Tennessee Valley Authority, Post Office Box 2000, Soddy-Daisy, Tennessee 37384-2000

TVA-SQN-TS-06-03 10 CFR 50.90

SEQUOYAH NUCLEAR PLANT (SQN) - UNITS 1 AND 2 - TECHNICAL SPECIFICATIONS (TS) CHANGE 06-03 "ULTIMATE HEAT SINK (UHS) TEMPERATURE INCREASE AND ELEVATION CHANGES"

TENNESSEE VALLEY AUTHORITY (TVA)
SEQUOYAH NUCLEAR PLANT (SQN)
UNITS 1 AND 2

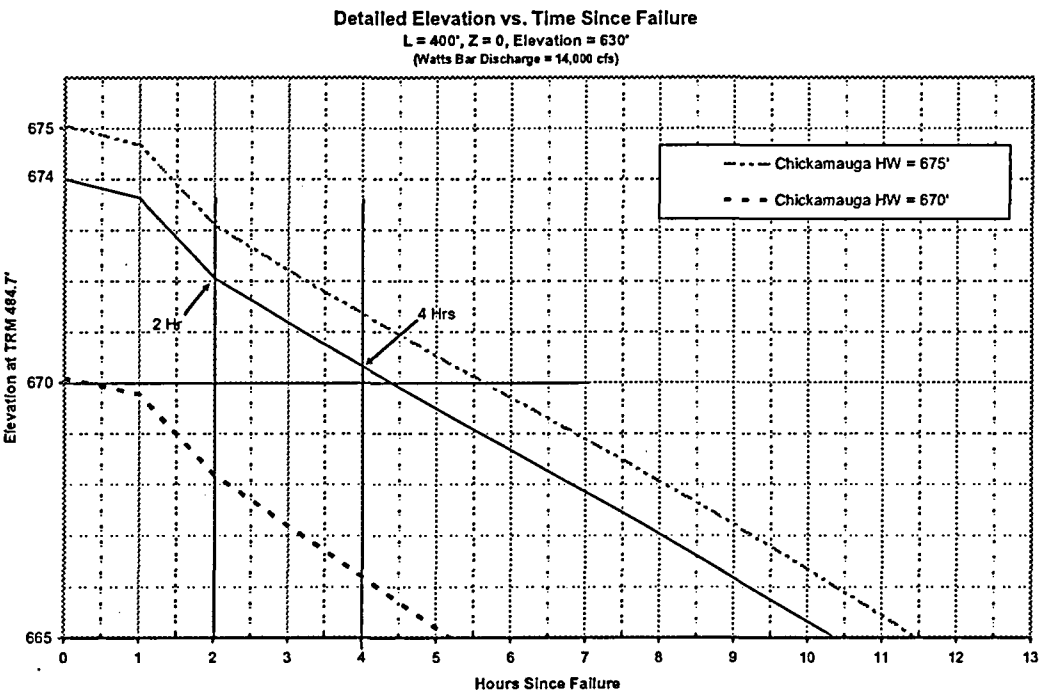
TVA has reviewed the recent ERCW flow balance and flow modeling (performance data). The review concludes that the components flow balanced at a river elevation of 670 feet are capable of supplying cooling water flow to support both short-term and long-term cooling needs following a LOCA and LODD. Also, a lower river level can supply the required minimum safety-related flows to the CCS and CS system heat exchangers without loss of net positive suction head; however, less operating margin exists which impacts operating fouling factors and requires removing equipment from service more frequently for flushing and biocide injections. TVA proposes a minimum river level of 674 feet for this UHS change request. An UHS elevation of 674 feet is conservative at 87°F, with regards to current analyzes and equipment performance data, to support essential heat loads following the accident events and provides at least 4 hours of river level above 670 feet following a LODD event (References 6 and 7). The below figure shows the river elevation change after the LODD. These

results are from Reference 8 with an overlay drawn-down curve for a river elevation starting point of 674 feet. A provision of 4 hours above the 670-foot system flow balance is adequate for compliance with the TS action statement, where the plant would be placed into Hot Standby (Mode 3) and in Cold Shutdown (Mode 5) within the following 30 hours, because lower river levels can supply the required minimum safety-related flow rates.
